STAFF REPORT

SUBJECT: H-2020-0113

Foxcroft Subdivision

D. Landscape Plans (date:11/11/2020 February 25, 2021)

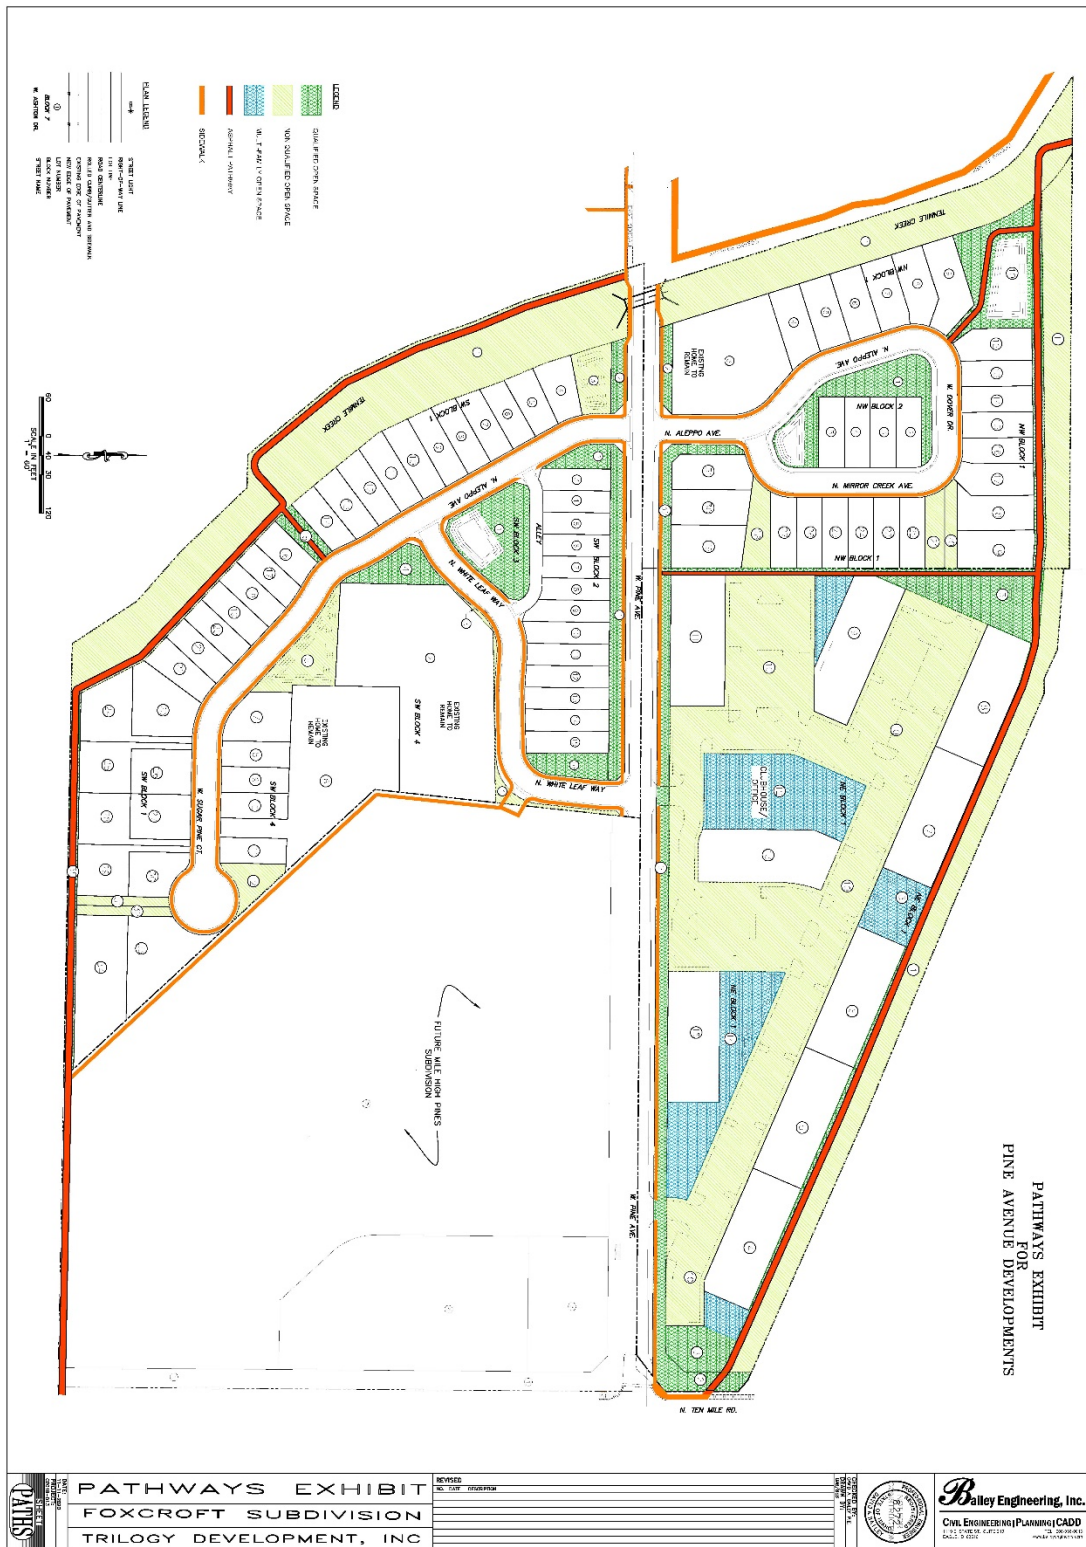
Landscaping is required along all pathways (including micro-pathways) in accord with the standards listed in *UDC 11-3B-12C*. The total lineal feet of *all* pathways with the required and proposed number of trees are included in the Landscape Calculations table on the submitted landscape plans, sheet L.4. The correct number of trees appear to be shown on the submitted plans. ***However, the required 5 feet of landscaping and trees on both sides of the pathways is not shown at any point throughout the site. Staff understands the pathways are encumbered by the Tenmile Creek to some degree. Therefore, at a minimum, the Applicant should apply for Alternative Compliance at the time of Final Plat submittal to show an adequate alternative to the required landscaping on both sides of the multi-use pathways.***

Prior to the City Council hearing though, the Applicant should revise relevant plans to reduce the depth of the lots along the southern boundary to include the required landscaping on both sides of the pathway in this segment. In addition, the segment that runs along the east side of the creek should widen the landscape area adjacent to the pathway to at least 5 feet; the submitted landscape plans show only a 3-foot wide area of landscaping. The lots adjacent to this segment can accommodate a loss of at least 2 feet in lot depth to include 5 feet of landscaping on at least one side of the pathway.

- 4. The landscape plan included in Section VII.D, dated ~~November 11, 2020~~ February 25, 2021, is approved as shown. shall be revised as follows prior to submittal of the Final Plat application:

- a. ~~Revise the landscape plans to add a 5-foot wide landscape buffer along both sides of the pathway segment located along the southern boundary of the site, landscaped in accord with UDC 11-3B-12.~~

- b. ~~Show at least 5 feet of landscaping on the east side of the pathway segment on the east side of the Ten Mile Creek and landscape in accord with UDC 11-3B-12~~

- c. ~~Show at least 5 feet of landscaping on the south side the pathway segment abutting Lots 12-19, NW Block 1.~~
 - 5. The Applicant shall apply for Alternative Compliance with ~~the first~~ each Final Plat submittal to propose an adequate alternative for all of the required pathway landscape requirements, in accord with UDC 11-5B-5.

E. Pathways and Pedestrian Circulation Exhibit

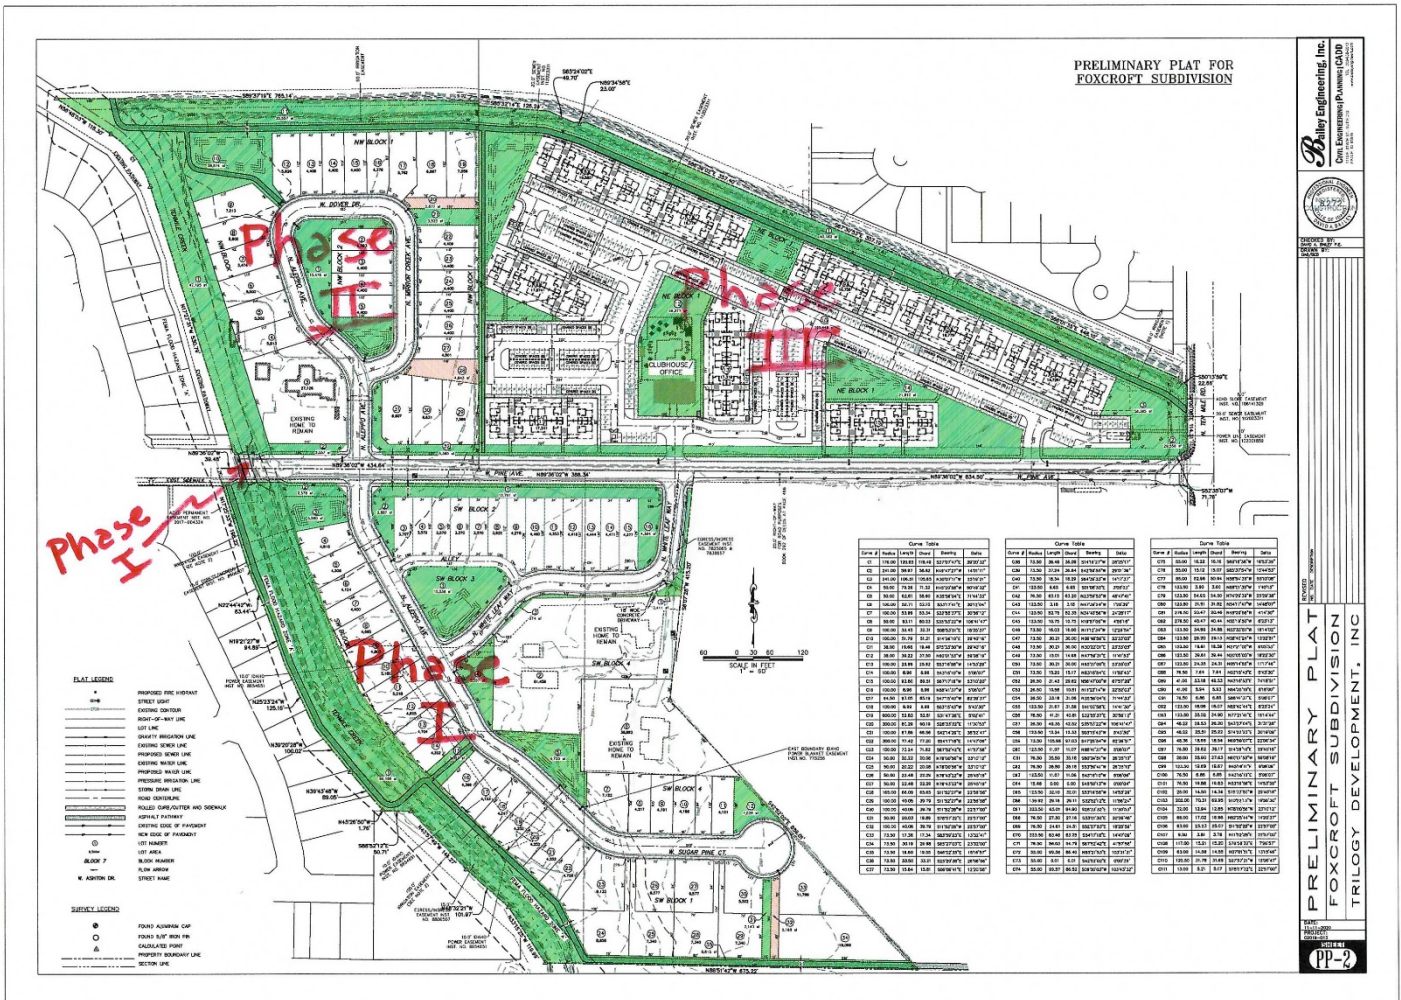
Despite all of the proposed pathways within the development, there is one additional connection that could tie together even more paths and add a quicker way for children to walk to Chaparral Elementary, if it can be done. Staff believes adding a new micro-path connection to the open space and pathway within Mosher's Subdivision to the northeast would be a great benefit to this development and the recently approved Mile High Pines. Adding a new connection to the school is not preferred by either the school district or Police because it creates another access point to monitor for safety reasons. Mosher Subdivision already has a dedicated micro-path connection to Chaparral so if this Applicant can work with the Mosher HOA and tie into their existing network, the overall pedestrian access to the school will be increased.

The sidewalks in this development create connections throughout the project including to and from the multi-use pathway segments surrounding the development. All open space areas also appear to be directly adjacent to sidewalks which add to the accessibility of these areas. Staff supports the sidewalk and pedestrian circulation plan for this development. See Exhibit VII.E.

H. Conceptual Building Elevations — Apartments

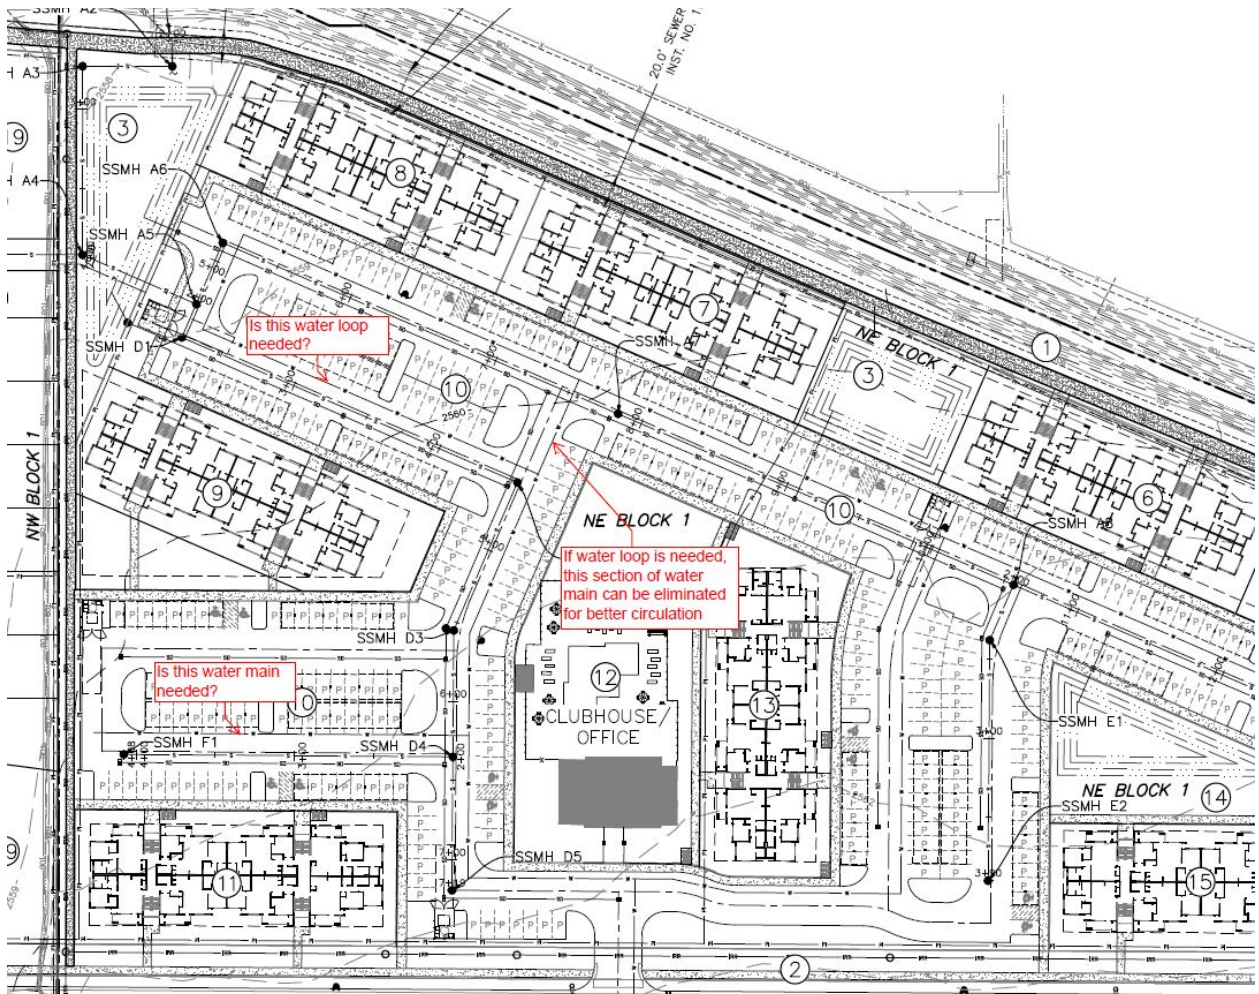
The submitted multi-family elevations show traditional, walk-up garden style apartment buildings. The buildings appear to have at least three field materials of stucco, lap siding, and stone and incorporate adequate roof plane variation along the roofline. The buildings all share the identical color palette which does create a singular identity.
